Cyclone House, 27-29 Whitfield Street, London W1T 2SE

Document to support Minor Material Amendment

PROJECT REFERENCE: 51517 18TH AUGUST 2017

1.2 THE PROPOSED AMENDED SCHEME

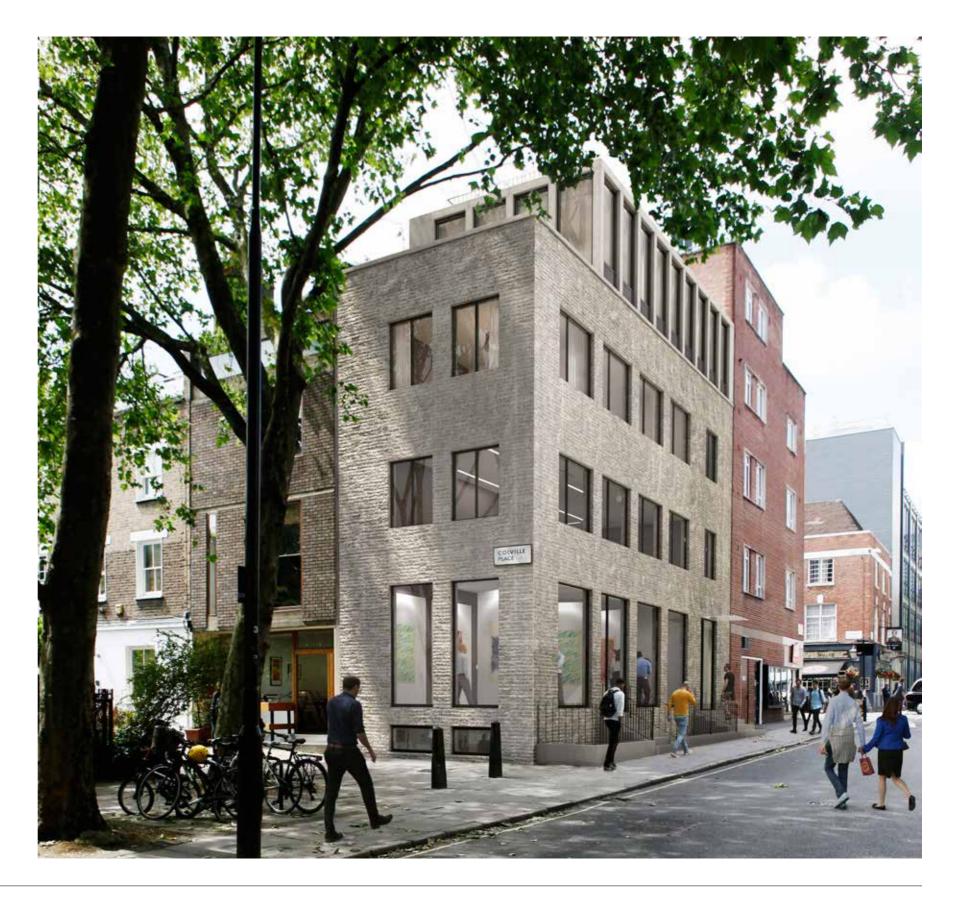
During recent exploratory works to the facade, it has become apparent that it is possible to remove the existing render and expose the original bricks beneath. Together with a limewash treatment to blend the existing and newly exposed brickwork, this greatly improves the appearance of the existing building.

The image to the left illustrates the amended design, which is exactly the same as the consented scheme in terms of height, bulk and mass. The only difference is the use of materials and the facade treatment.

Following this approach, the rooftop extension would need to clearly distinguish itself as a new addition to the existing building. We seek to achieve a simple contemporary design through the use of slender concrete frames with vertical glazed elements in between. The use of concrete relates well, both to the treated brickwork beneath and the adjacent modernist listed building at no. 1 Colville Place. The slenderness of the frames and vertical alignment gives the extension a lighter appearance.
